# **RESPONSIVENESS SUMMARY TO THE PEER REVIEW OF MODEL CALIBRATION: MODELING STUDY OF PCB CONTAMINATION IN THE HOUSATONIC RIVER**

DCN: GE-080105-ACUD

**Environmental Remediation Contract  
GE/Housatonic River Project  
Pittsfield, Massachusetts**

**Figure GI-4-1 Grid Proposed by EPA During MFD Peer Review**

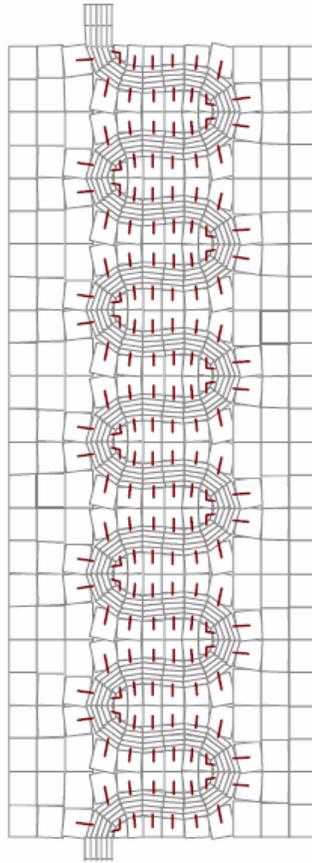
All seven Reviewers commented that the representation of the main river channel with a width of one cell in the EFDC model grid was problematical and did not allow for accurate simulation of the lateral variation for certain important processes and variables. Processes and parameters noted most often in this regard included flow, sediment-water contaminant flux, bottom shear stress, and erosion potential. One Reviewer noted that the necessary lateral averaging of parameters used to evaluate the calibration (e.g., TSS) would have the effect of artificially improving the apparent goodness of calibration. Most Reviewers recommended a minimum of three lateral cells to represent the channel.

Several Reviewers criticized this representation of the river by three grid cells across the channel width. One Reviewer discussed the importance of secondary flows, implying that he thought a three-dimensional representation of the river channel was required, and recommended against the use of the computational grid shown in Figure GI-4-1. Another Reviewer commented that a three-dimensional grid was not necessary, but recommended additional resolution in the river channel that would result in 4 to 5 cells across the river in much of the model domain. Other Reviewers believed that simpler approaches would be better.

The complexity of the Primary Study Area (PSA) poses a challenge for developing a computationally efficient but physically comprehensive model. Due to the complex bathymetry and morphology of the Housatonic River, the circulation and flow regimes are also complex.

**Figure GI-7-2 Concentrations of Total Suspended Solids (TSS) and PCBs for Original and Alternate Phase 1 Model Calibration**

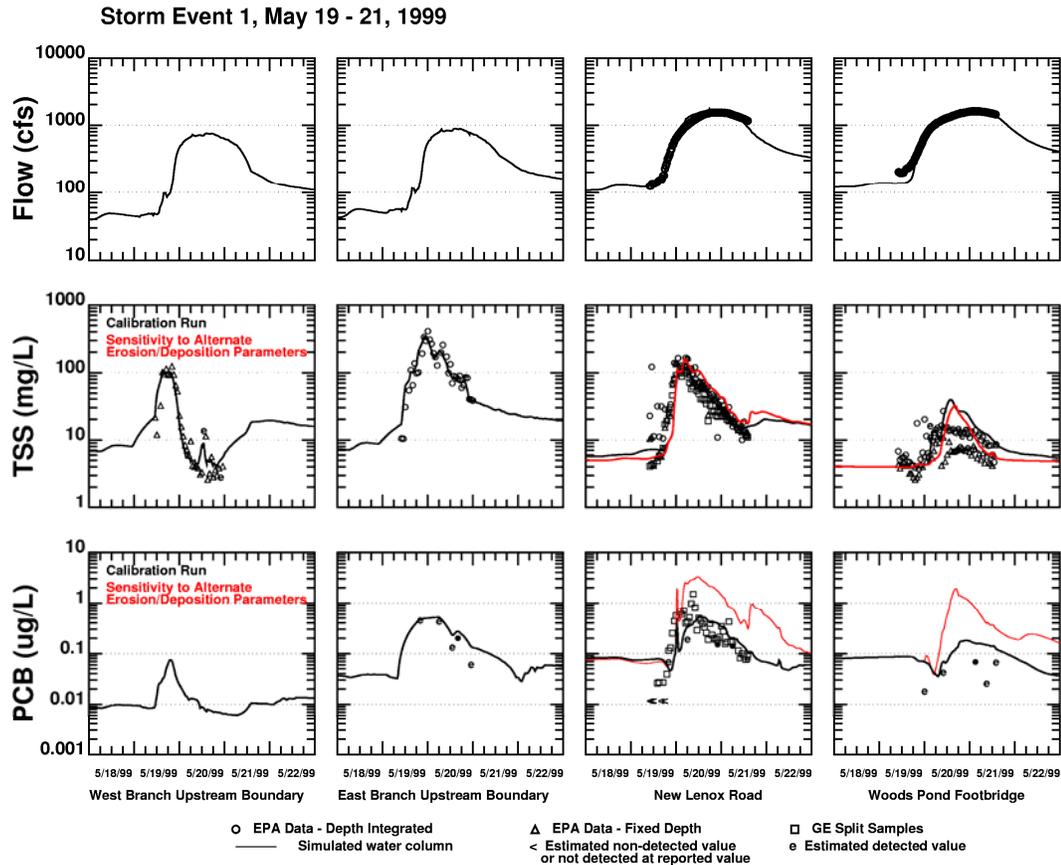
27 In extensive comments regarding this issue, one Reviewer provided a detailed discussion of  
28 resuspension processes, indicating the exponent used in the model formulation for calculating  
29 resuspension on the basis of excess shear stress was incorrect and recommending additional  
30 Sedflume experiments. This Reviewer was also critical of the effect that the 6-inch sediment  
31 active layer would have on the process of bed armoring. The Reviewer also commented on the

11 To demonstrate the constraints that water column PCB concentrations place on  
12 the specification of resuspension and settling rates, an alternate parameterization  
13 of resuspension and deposition was specified for a simulation of Event 1. The  
14 alternate parameterization consisted of a reduction in the critical shear stress for  
15 cohesive solids resuspension and an increase in the cohesive solids settling  
16 velocity, resulting in an increase in the exchange between water column and bed  
17 solids. Results from the original Phase 1 Calibration and this alternate  
18 parameterization of resuspension and deposition are presented in Figure GI-7-2.  
19 Although the increased resuspension flux of solids from the bed was offset by  
20 increased deposition, and similar water column TSS profiles were achieved,  
21 water column PCB concentrations increased by approximately a factor of five,

22 making the simulation results from the alternate parameterization inconsistent  
23 with the data. Thus, Mr. Endicott's observation regarding the constraint that  
24 reproducing both suspended solids and water column PCB concentrations  
25 imposes on parameterization of resuspension and deposition applies to the  
26 Housatonic River, and the satisfactory reproduction of water column PCB  
27 concentrations demonstrates that resuspension and deposition processes have  
28 been parameterized correctly.

**Figure GI-12-1 Comparisons of Simulated vs. Measured Velocities at Holmes Road, New Lenox Road, and Woods Pond Footbridge**

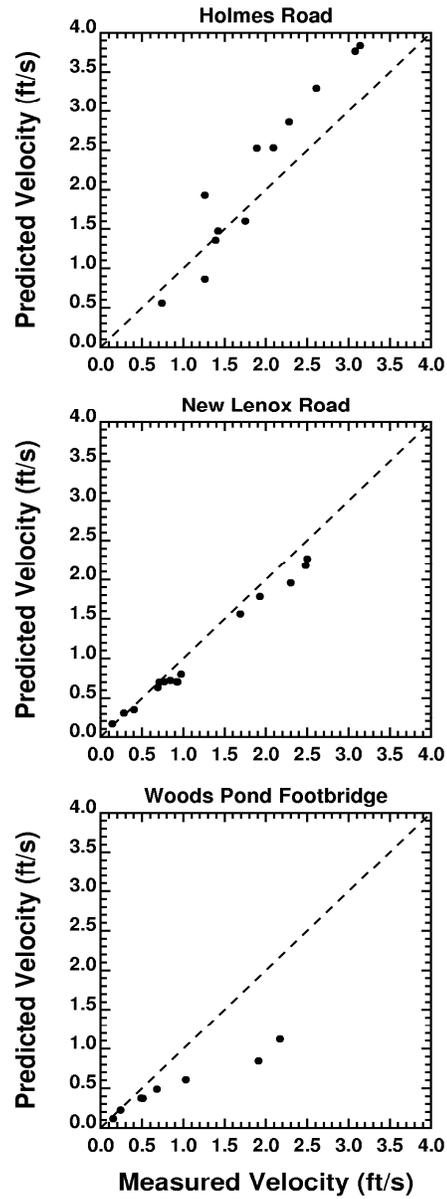
11 All of the Reviewers made some comments that suggested ways that the models could be  
12 improved or tested to better demonstrate model calibration and/or correct representations of  
13 processes. Examples of these (which are not represented by another General Issue) include:

- 14       ▪ Plots of measured versus simulated TSS as an “equivalence” plot.
- 15       ▪ Conduct a “trial” remediation (although this is not possible in a real sense, it can be  
16       simulated) and evaluation of the model response.
- 17       ▪ Comparison of velocity data to simulated velocities.
- 18       ▪ Compare simulated erosion and deposition patterns to the data showing locations and  
19       changes in bed elevation (including Woods Pond).
- 20       ▪ Show the proportion of PCB burden in different species/trophic levels attributable to  
21       water-related versus sediment-related sources.
- 22       ▪ Evaluate PCB fluxes between the river and floodplain during overbank flow  
23       conditions.
- 24       ▪ Use statistical methods such as mean squared error or confidence limits in making  
25       model/data comparisons to supplement the uncertainty analyses.

- 27       ▪ EPA agrees that plots of measured vs. simulated TSS would be useful  
28       and will include these figures in the Model Validation Report.
- 29       ▪ EPA agrees that simulation of an example remediation would be useful as  
30       a demonstration of model performance and will consider inclusion of one  
31       or more such simulations in the Model Validation Report.

10 **Figure 2-JL-1 Comparison of Measured Fish PCB Concentrations to FCM**  
11 **Simulations Assuming Mixed Habitat Use of the Mainstem and**  
12 **Associated Backwaters**

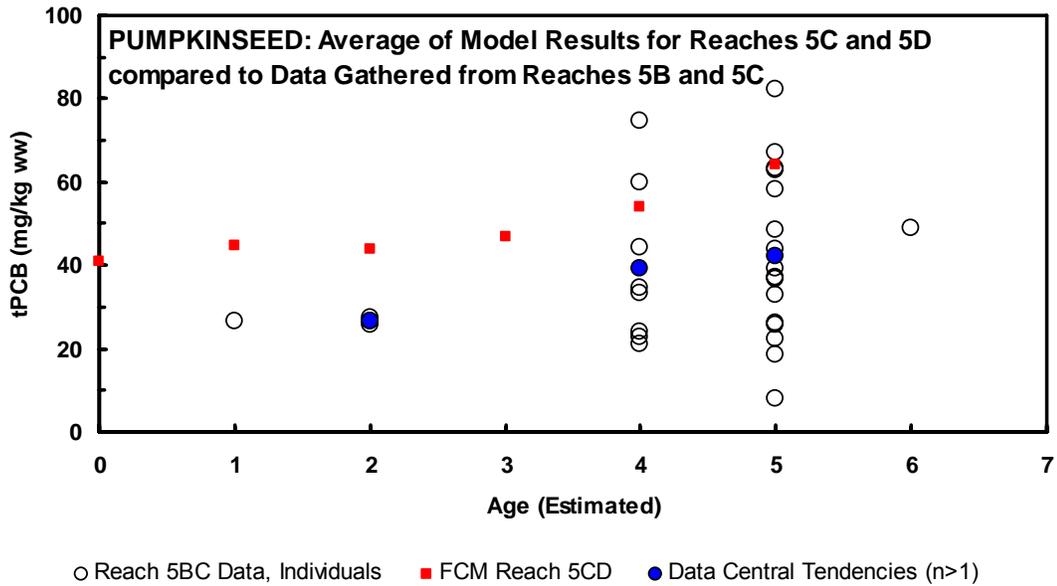
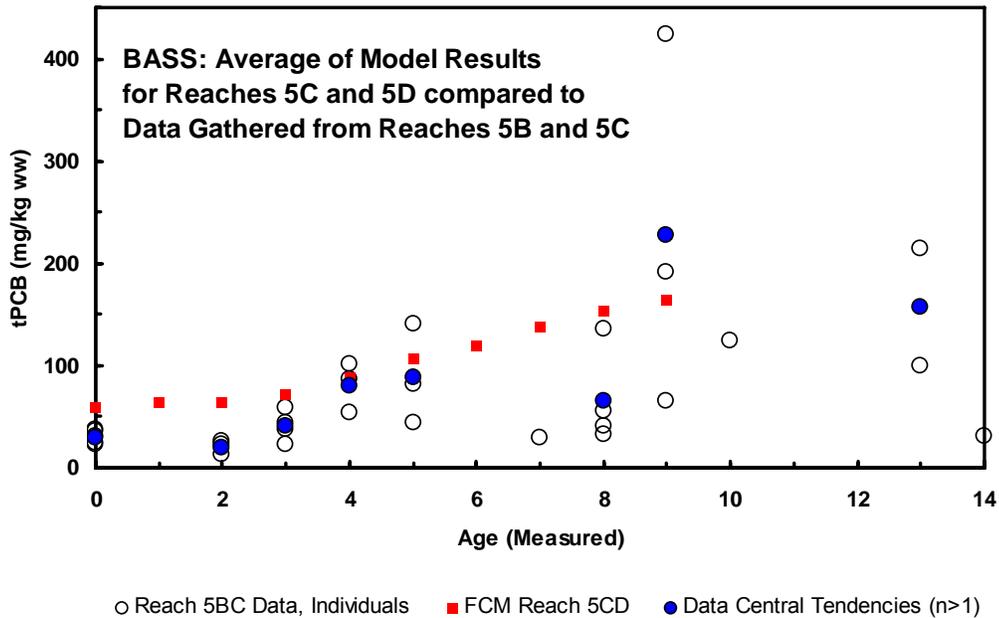
32 There certainly appears to be bias in the FCM as indicated by the lipid-normalized PCB  
33 concentrations predicted by the FCM in Reach 5D of the PSA, as indicated by Figure 19 of  
34 Attachment C.16, and other portrayals of the FCM predictions for Reach 5D that are included in  
35 Attachment C.16. It is unfortunate that there appears to be no field data to substantiate the  
36 predictions of the FCM in this reach of the river, especially since the predictions appear to be  
37 incongruent with those for the rest of the PSA. In the absence of any explanation and/or

9 It appears that the Reviewer is commenting on the discrepancy between Reach  
10 5D simulations and the simulations in adjacent downstream reaches (i.e., Reach  
11 5C and Woods Pond). Although this difference is not bias per se, discussion of  
12 the uncertainty associated with the difference, and the implications for model  
13 application, is appropriate.

14 Fish samples were not collected within Reach 5D (i.e., large backwaters  
15 contiguous to Reach 5C) because the backwaters were not accessible at the  
16 time the samples were collected. However, evaluation of largemouth bass life  
17 history indicates that fish migrate back and forth between the backwaters and the  
18 main channel of the Housatonic River. Therefore, the fish tissue data collected  
19 for Reach 5C represent mixed exposures to contaminated media in both  
20 Reaches 5C and 5D, with the degree of backwater habitat use dependent on  
21 flow, temperature, dissolved oxygen, and other habitat factors. When the habitat  
22 uses of Reaches 5C and 5D are considered and weighted by expected exposure  
23 duration, the model predictions remain close to the observed main channel  
24 concentrations, and within the tolerance limits for calibration specified in the  
25 MFD/QAPP.

26 Figure 2-JL-1 shows the results of additional linked model simulations in which  
27 model estimates from Reaches 5C and 5D were averaged, assuming 50%  
28 exposure from each reach. Even after the influence of backwaters exposure is  
29 taken into account, the measured and simulated concentrations remain in  
30 reasonable agreement.

1  
2 **Figure 3-WL-9a Erosion Rate Versus Shear Stress (as a function of depth in core)**  
3 **for Sedflume Experiments on Sediment with Median Particle**  
4 **Diameter ( $D_{50}$ ) Less than  $30 \mu\text{m}$**

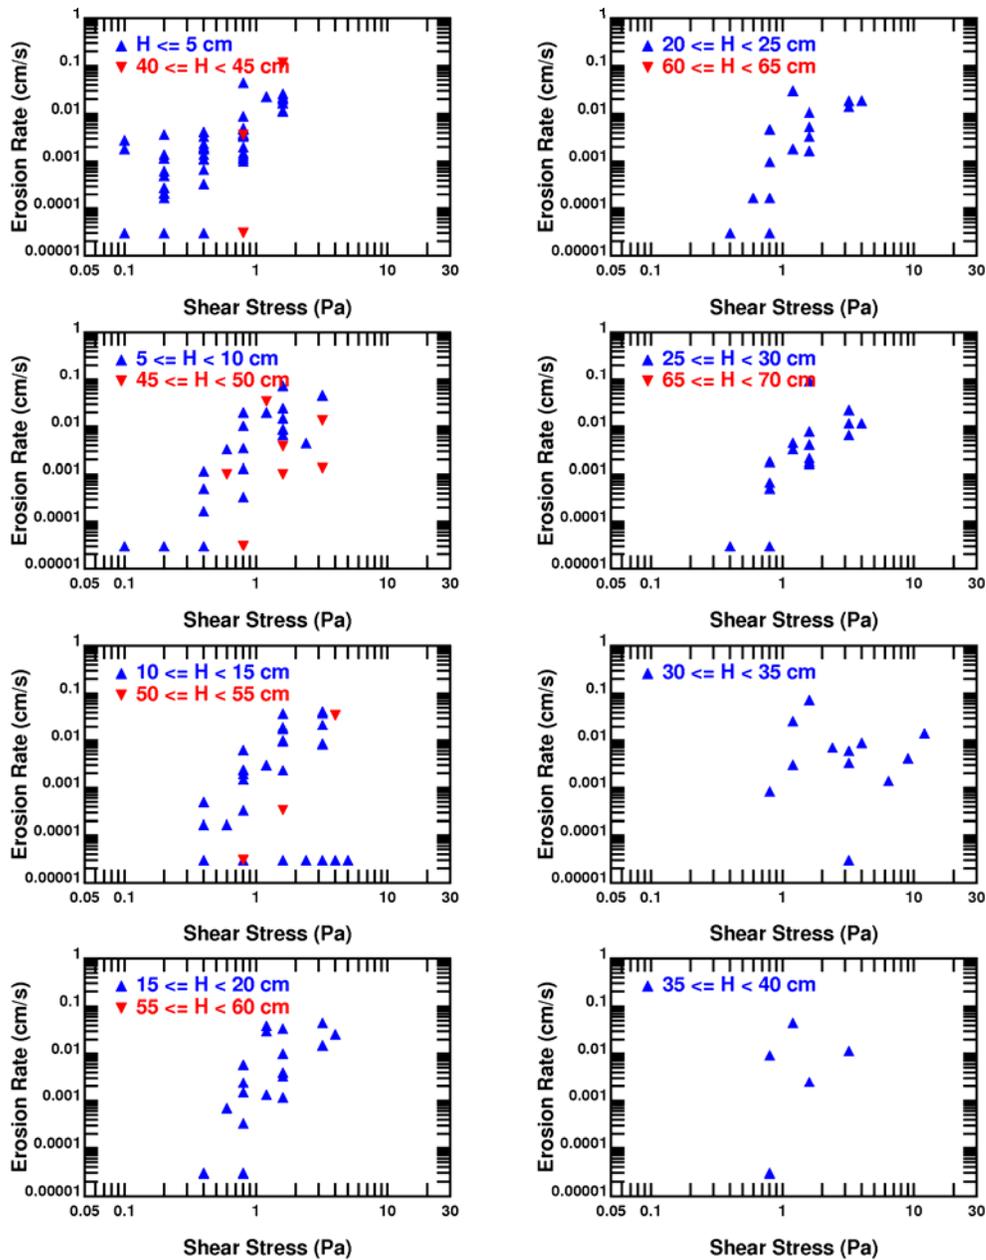
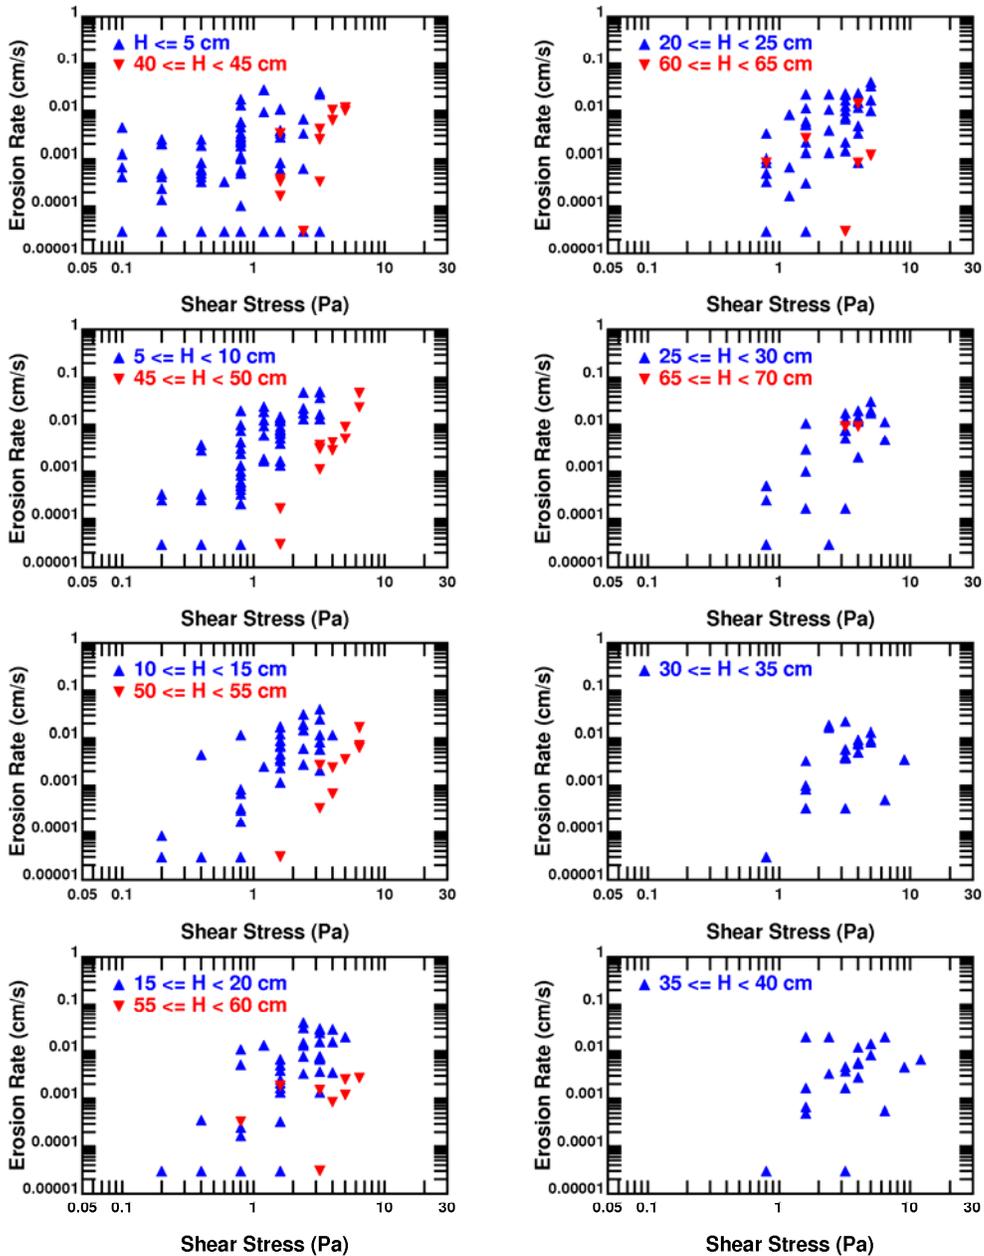
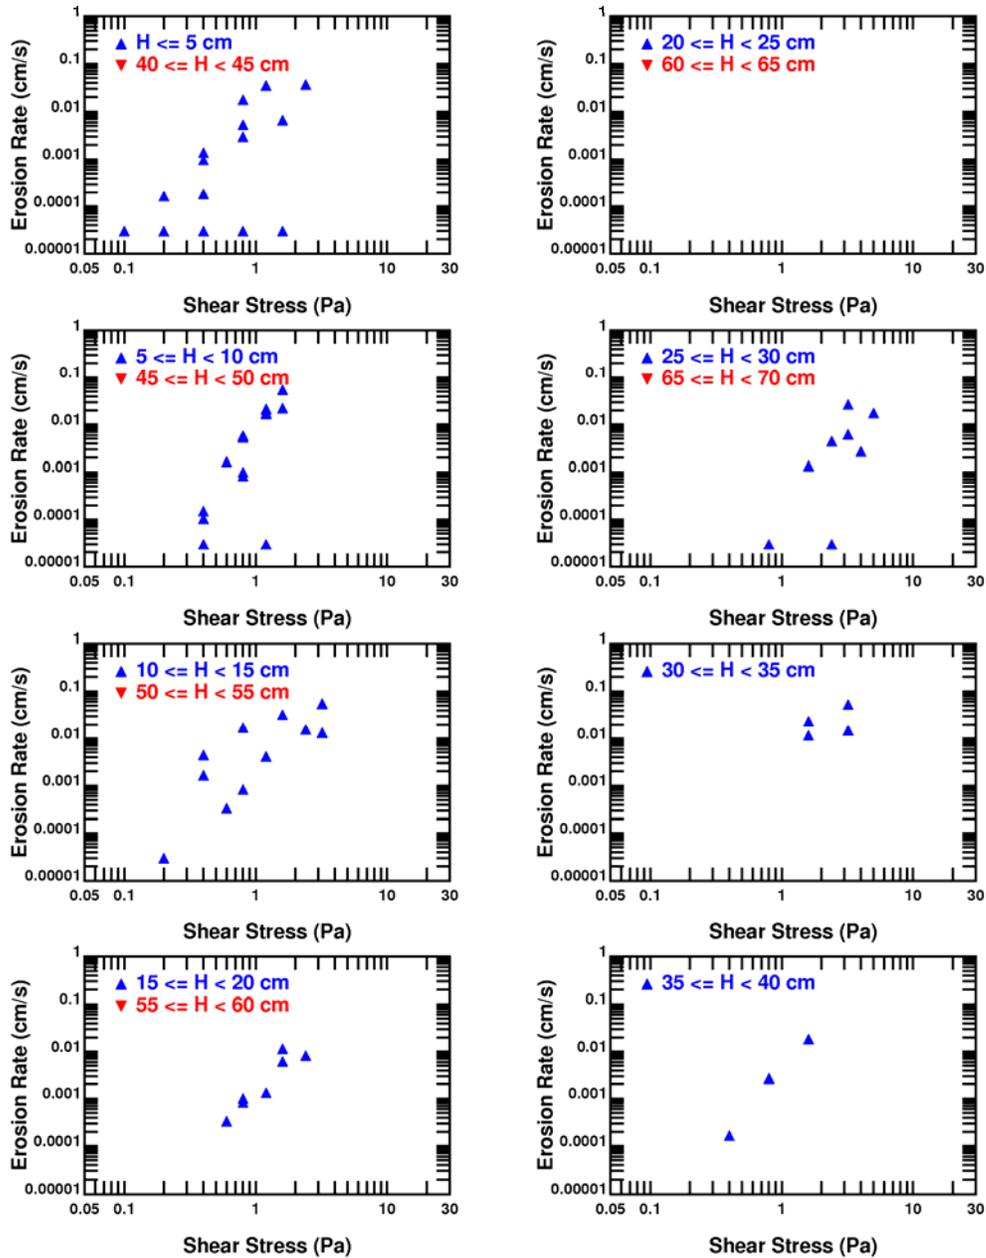
22          A way to group sediments with approximately the same bulk properties is as follows. (1)  
23          Separate sediments into fine, medium, and coarse sizes (this reduces the particle size effect) and  
24          (2) separate sediments by depth in the bottom sediments, e.g., 0 to 5 cm, 5 to 10 cm, 10 to 15 cm,  
25          etc. (the depth is a surrogate for changes in bulk density due to consolidation and hence this  
26          procedure normalizes the effect of density on the erosion rate).

28          The approach for analyzing the data suggested above was followed, but it does  
29          not result in an improved characterization of the resuspension data. The results  
30          of the analysis are shown in Figures 3-WL-9a, b, and c. Each figure displays the  
31          data for a different particle size ( $D_{50} < 30 \mu\text{m}$ ,  $30 \mu\text{m} \leq D_{50} < 100 \mu\text{m}$ , and  
32           $D_{50} \geq 100 \mu\text{m}$ , respectively) to reduce the particle size effect, and each panel  
33          presents data for different depth intervals (<5 cm, 5–10 cm, 10-15 cm, etc.) in an  
34          effort to account for changes in bulk density. When stratified in this manner,  
35          there is still considerable scatter in the data, an indication that factors other than  
36          particle size and bulk density are affecting the magnitude of the shear stress
